**MADISON AND WAHSINGTON ELEMENTARY SCHOOL ADDITION & RENOVATION  
HURON SCHOOL DISTRICT 2-2  
HURON, SOUTH DAKOTA**

KOCH HAZARD ARCHITECTS

ADDENDUM DATE: March 12, 2014

**ADDENDUM-1**

PROJECT NO.: 1278  
DATE: 3/10/14  
DRAWN BY: DMG  
CHECKED BY: CPH/MLT  
PROJECT: MADISON ELEMENTARY SCHOOL, SITE PHASE II  
SHEET TITLE: DRIVEWAY, GUTTER, SIDEWALK & ASPHALT PAVING & SCHOOL SIGN  
HIRON SCHOOL DISTRICT  
PRELIMINARY NOT FOR CONSTRUCTION  
C 1.9

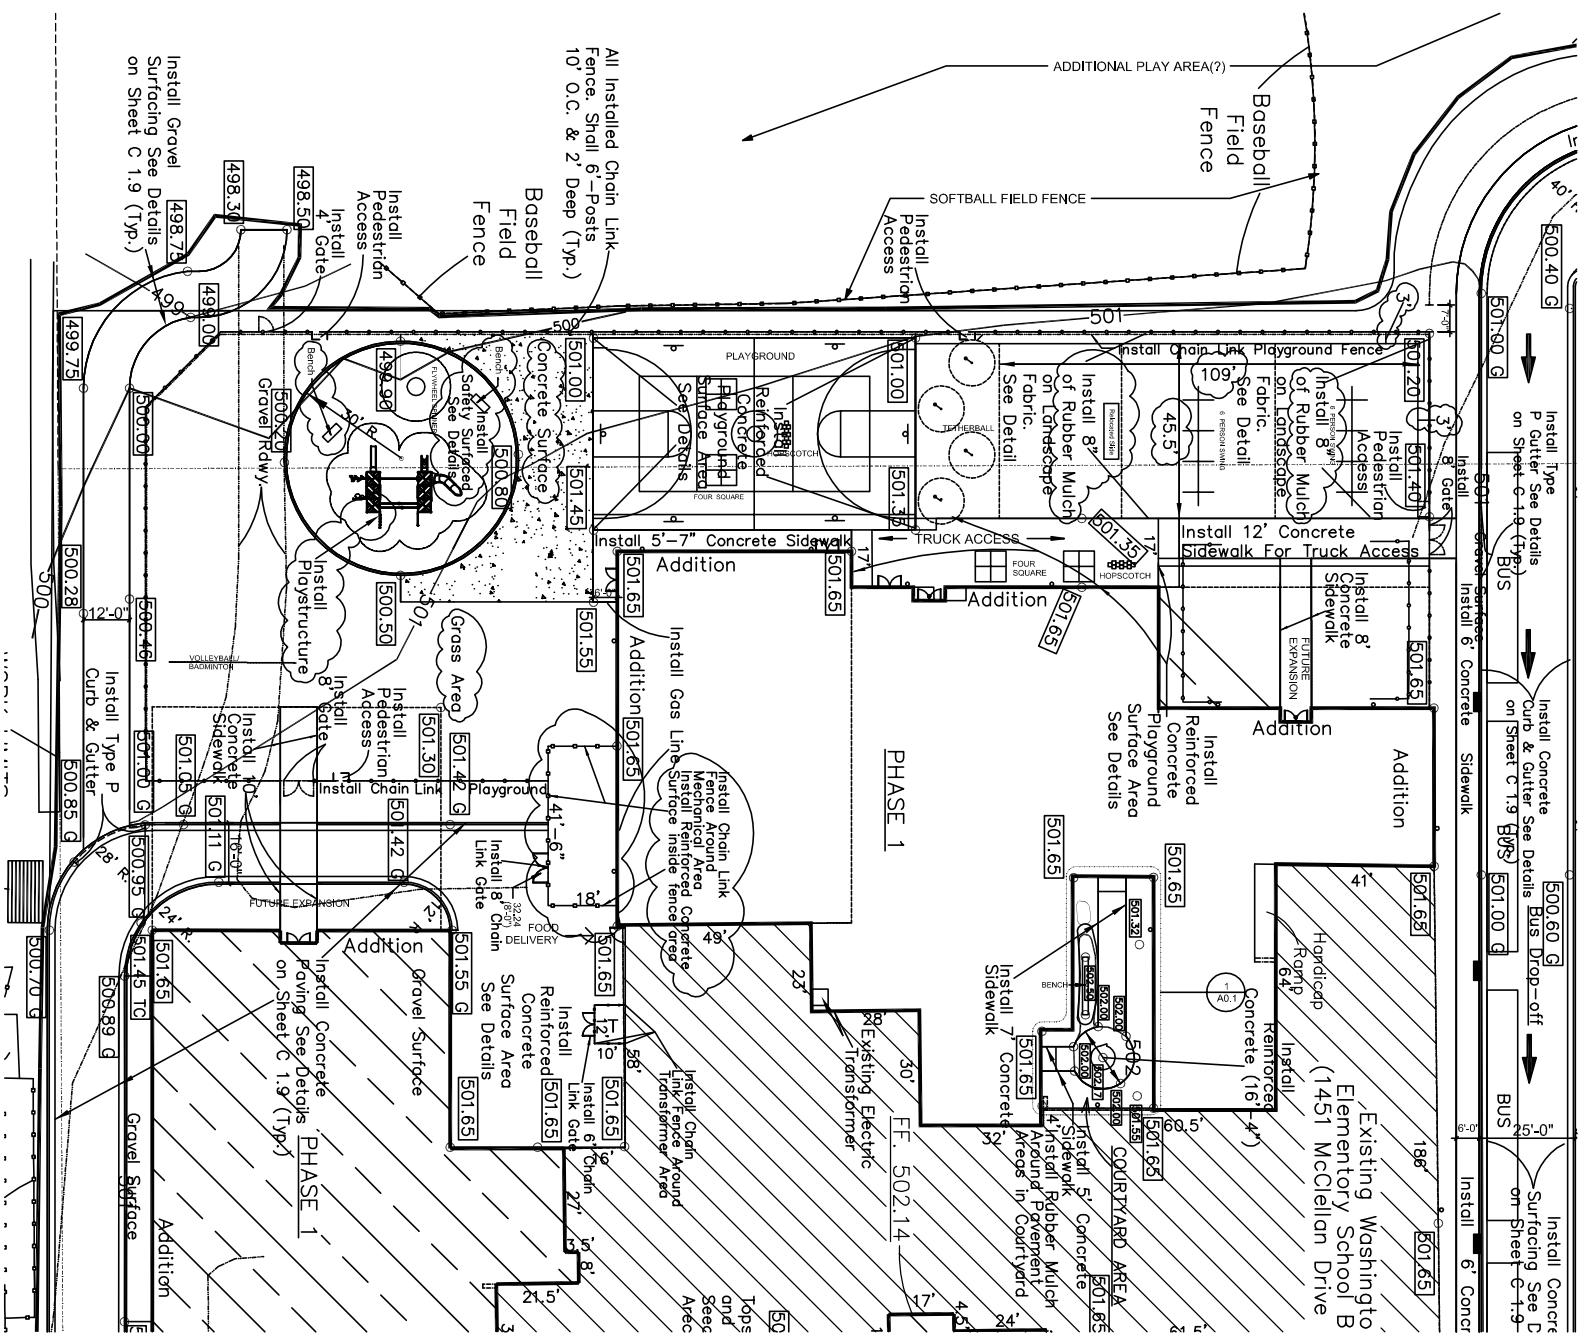
1. See attached Revised Drawing C1.9 for revised details.

**C 1.8**

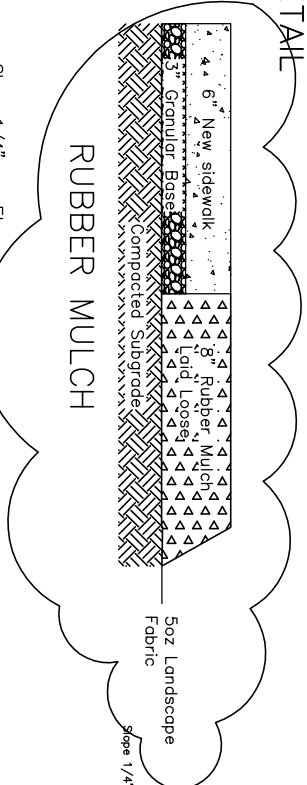
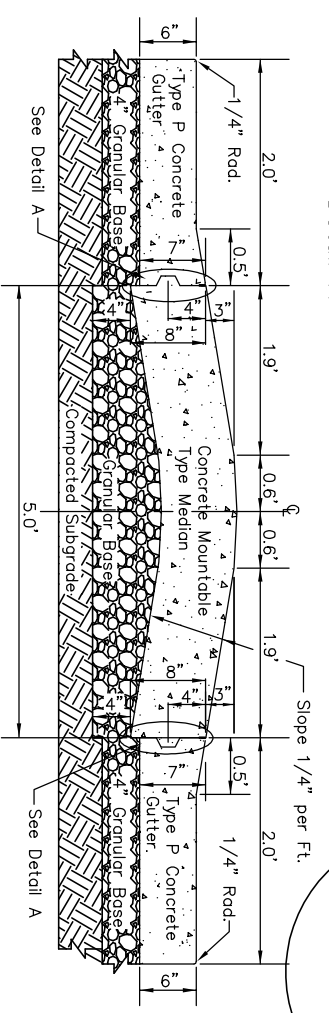
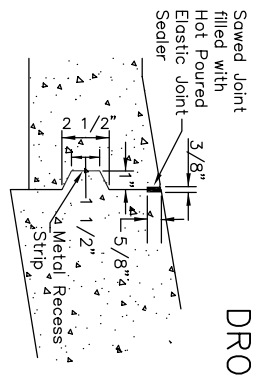
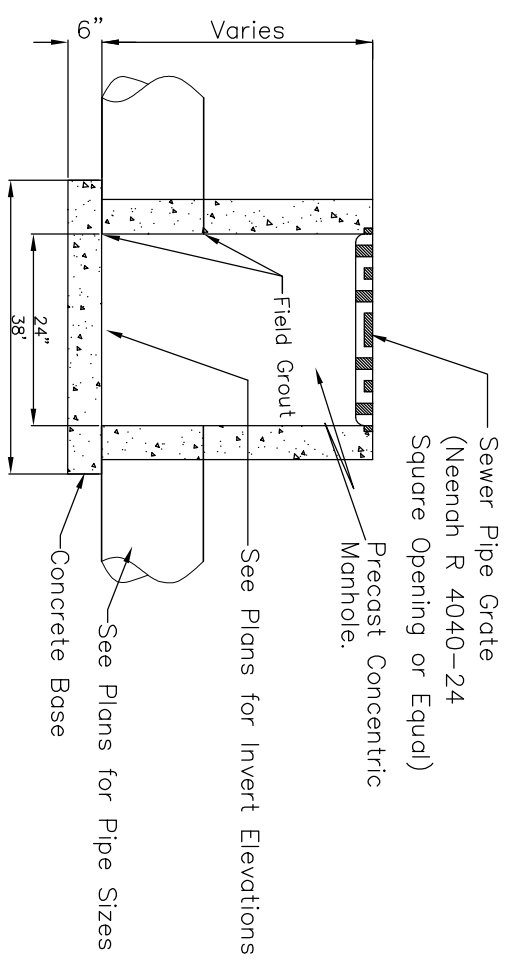
1. See attached Revised Drawing C1.8 for revisions to the playground area, fence and concrete area.

**C 1.9**

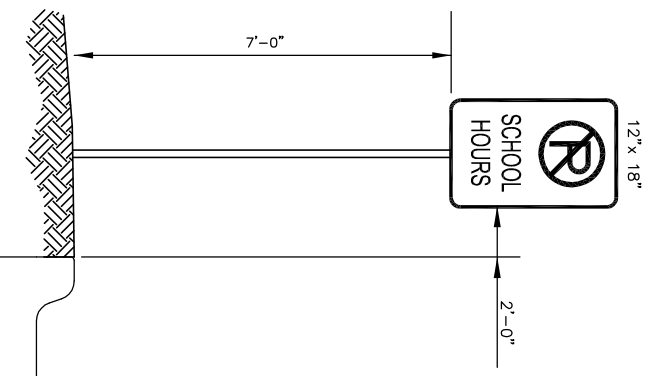
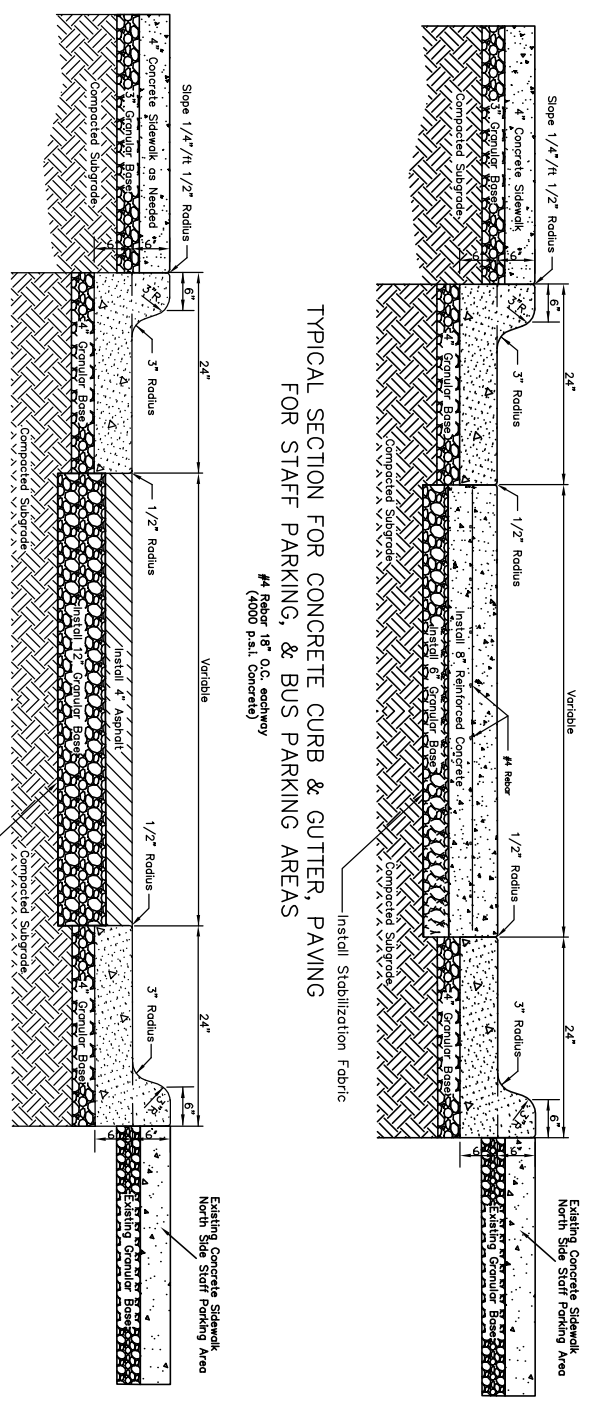
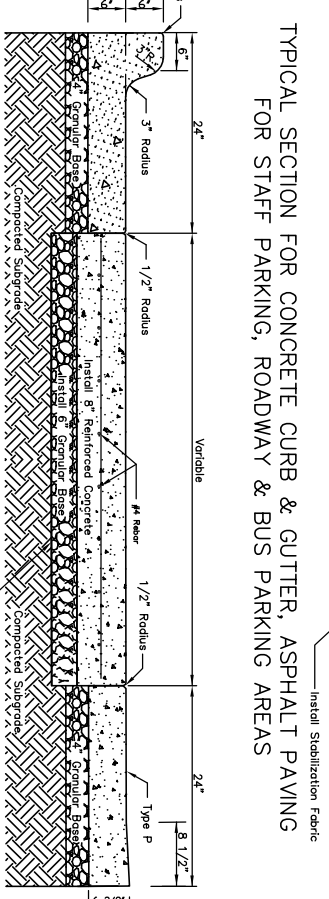
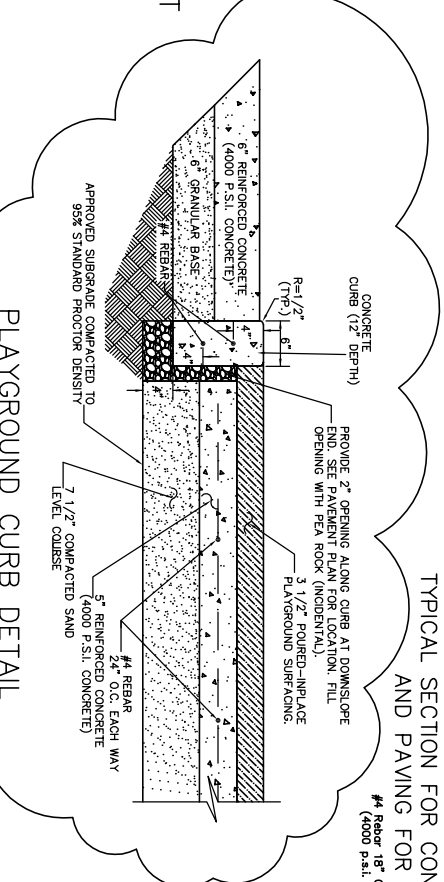
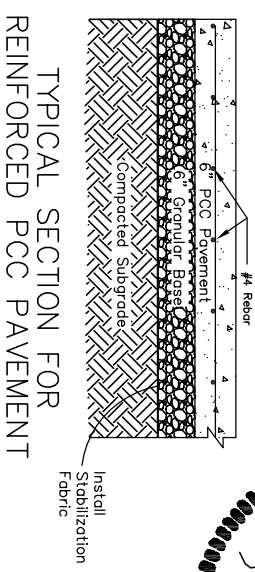
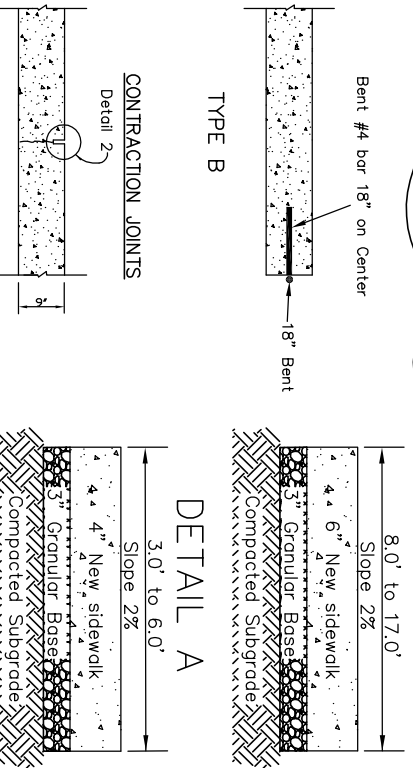
2. See attached Revised Drawing C1.9 for revised details.

PROJECT NO.: 1277A  
 DRAWN BY: ADG  
 DATE: 03/12/14  
 COPYRIGHT: 2013  
 PROJECT: Washington 4 - 5 Center Addition & Renovation  
 Huron School District  
 Huron, SD  
 SHEET TITLE: BAND/ORCH ROOM ELEVATION

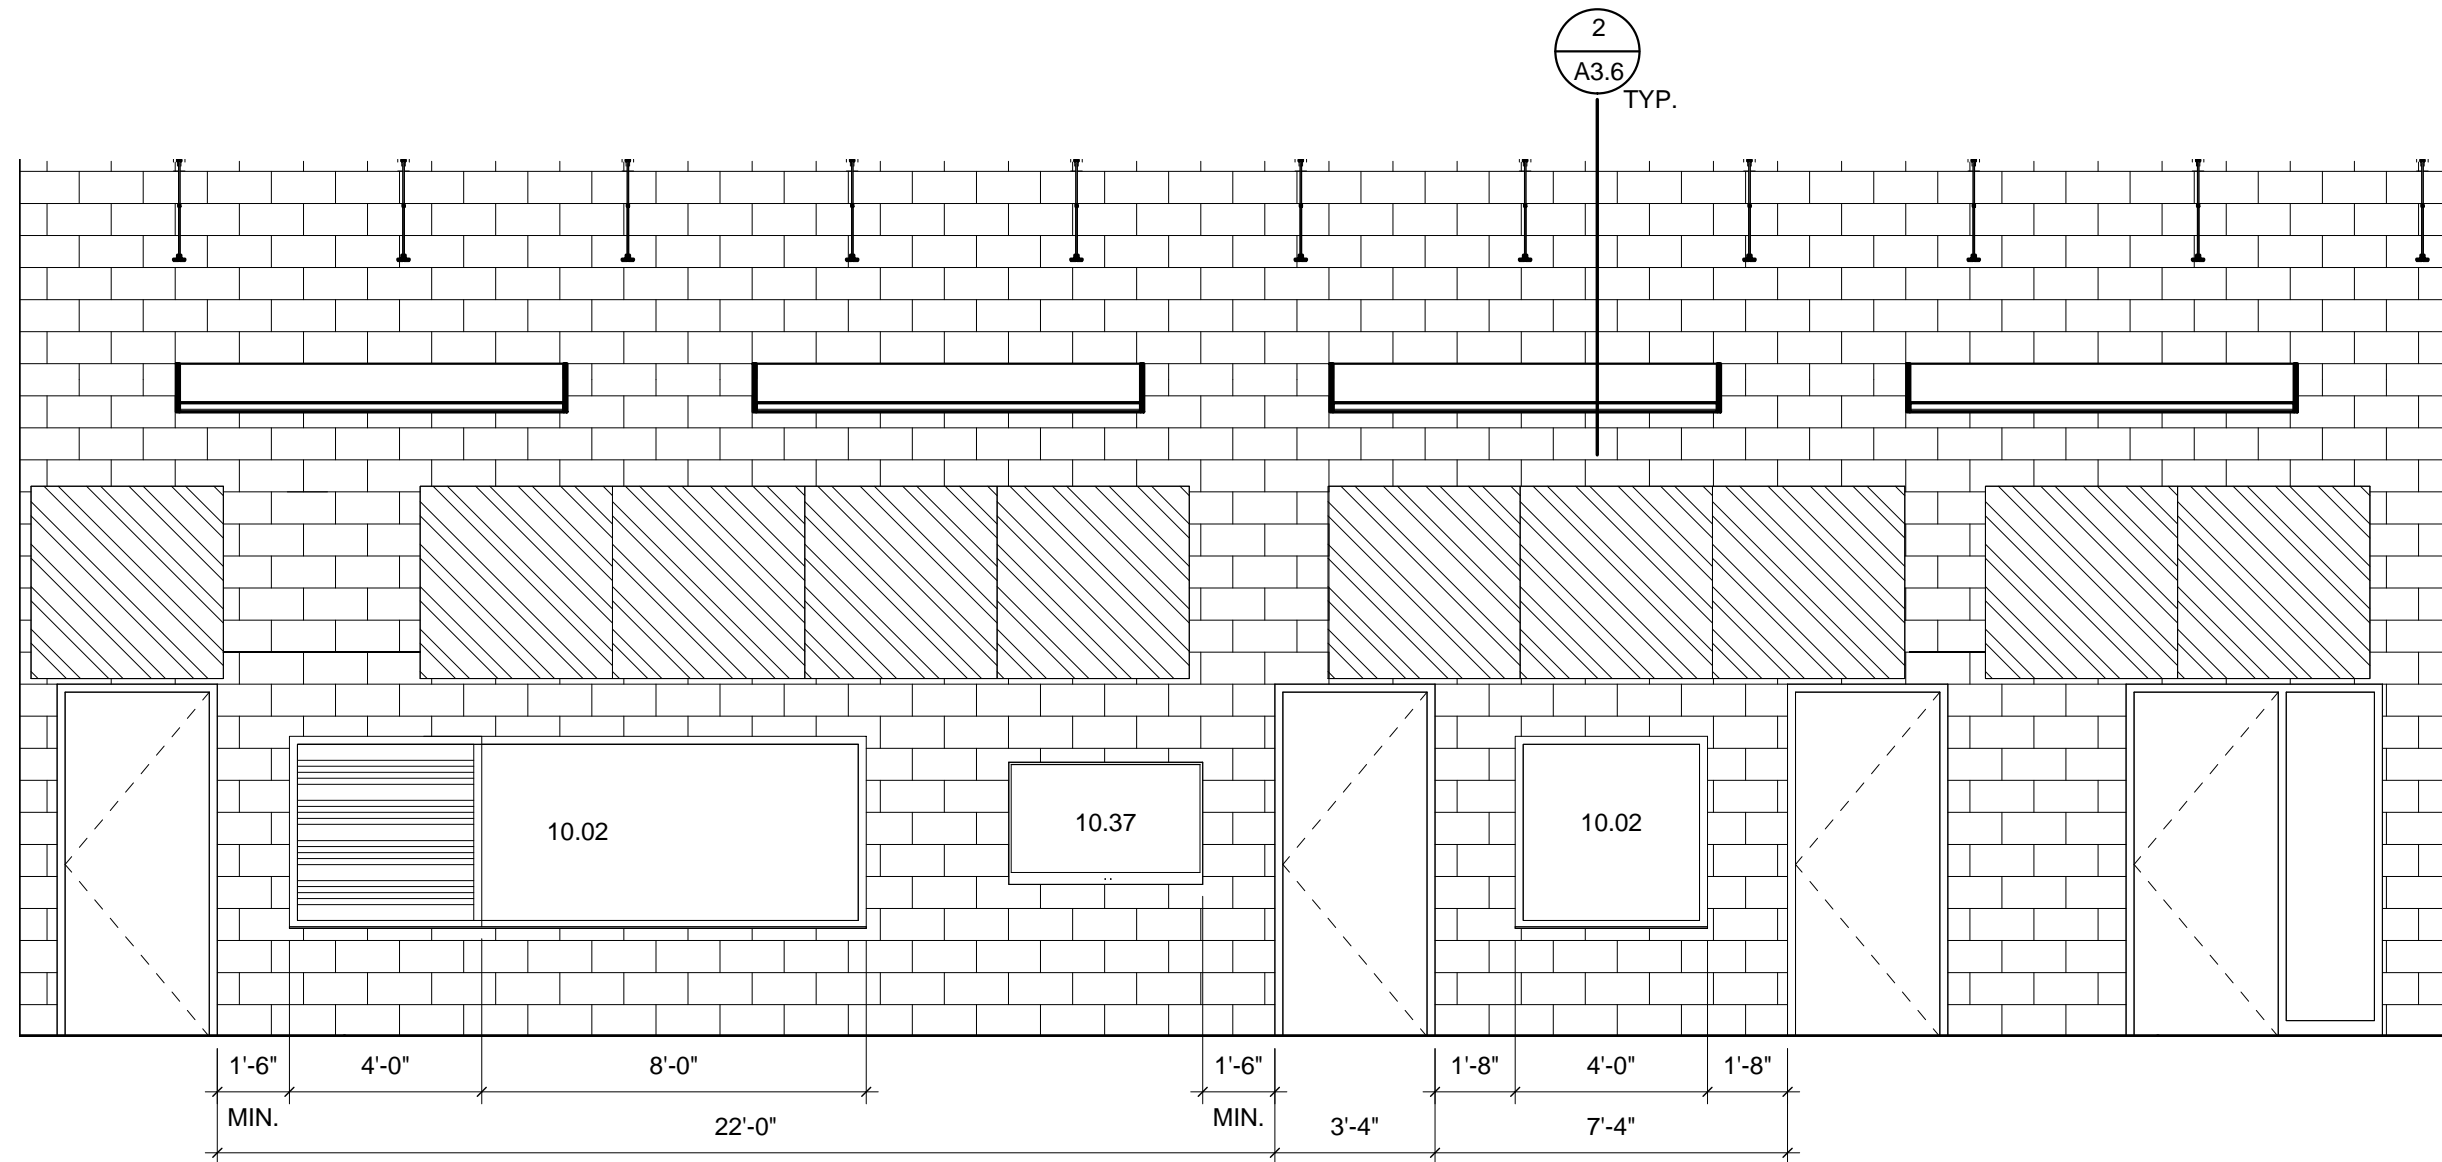
1. Room 141 Band/Orchestra, Room Finish Box; change room height to 13'-0" in lieu of 11'-6".
2. Detail 9 Band/Orch Elevation - revised elevation Drawing ADD-1, A1.3 attached.

**RM1. 1**

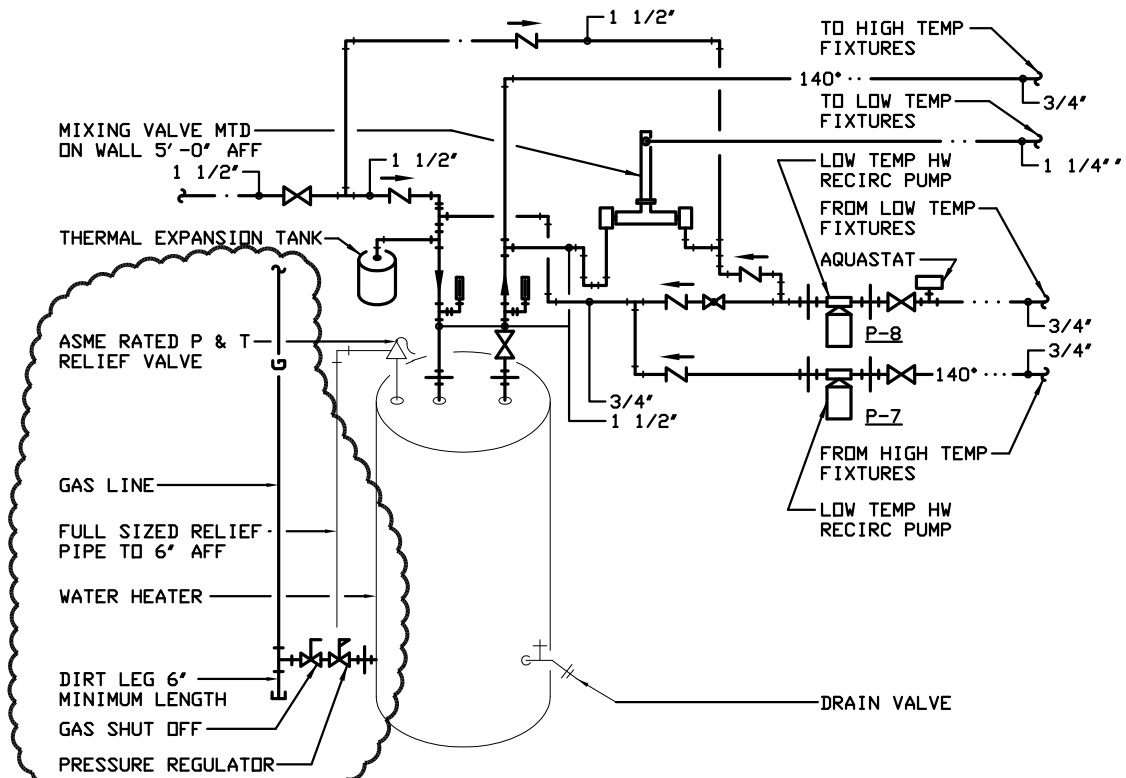
1. Added Gas piping to BOILER PIPING DETAIL and WATER HEATER PIPING DETAIL
2. See attached Drawing Sheet RM1.1, dated 3-11-14, sheet 4 of 5.

SHEET  
**RM3. 5**  
**5 OF 5**

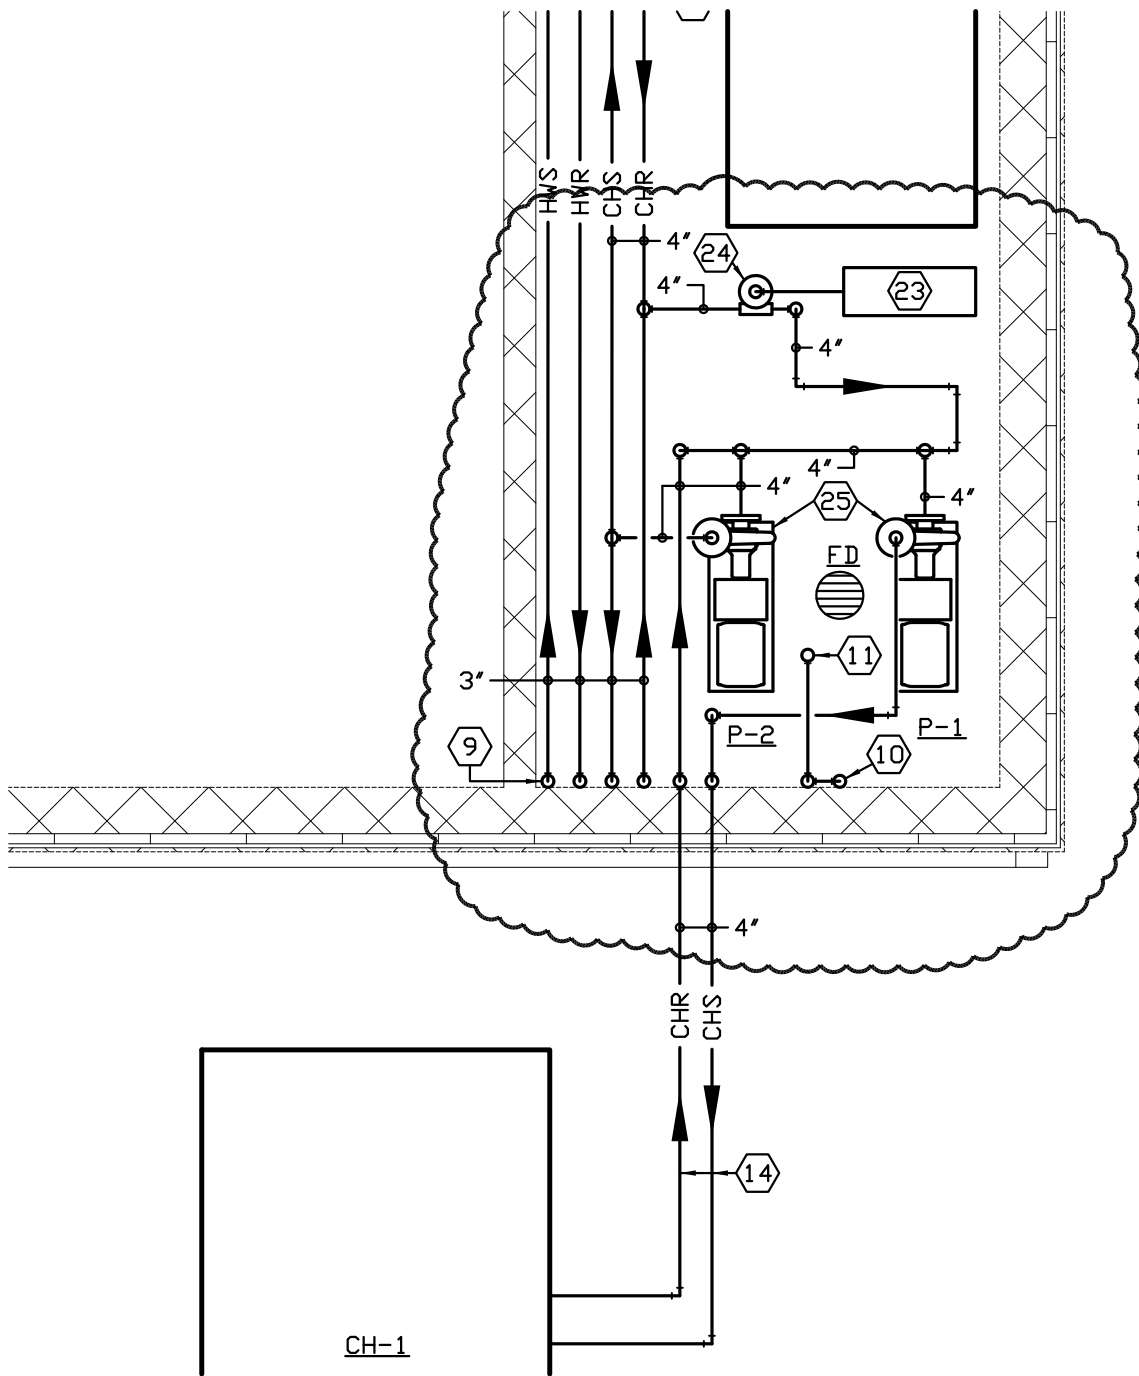
1. Note 35 – Add: The boiler modification shall include but not be limited to the following:
  - Probe type low water cut-off M & M 750-MT-120.
  - Replace pressure control with temperature control Honeywell L4006A1009.
  - Temperature high limit with manual reset L4006E1067.
  - Replace steam relief with hot water relief (50 psi).
  - Replace pressure gauges.
  - Replace pressure control with hot water modulating control T991, L6006 or equal.
2. Revised CHS & CHR Piping in ENLARGED PENTHOUSE ROOM 163 PLAN – PLUMBING & HEATING. See attached Drawing Sheet RM3.5, dated 3-11-14, sheet 5 of 5.
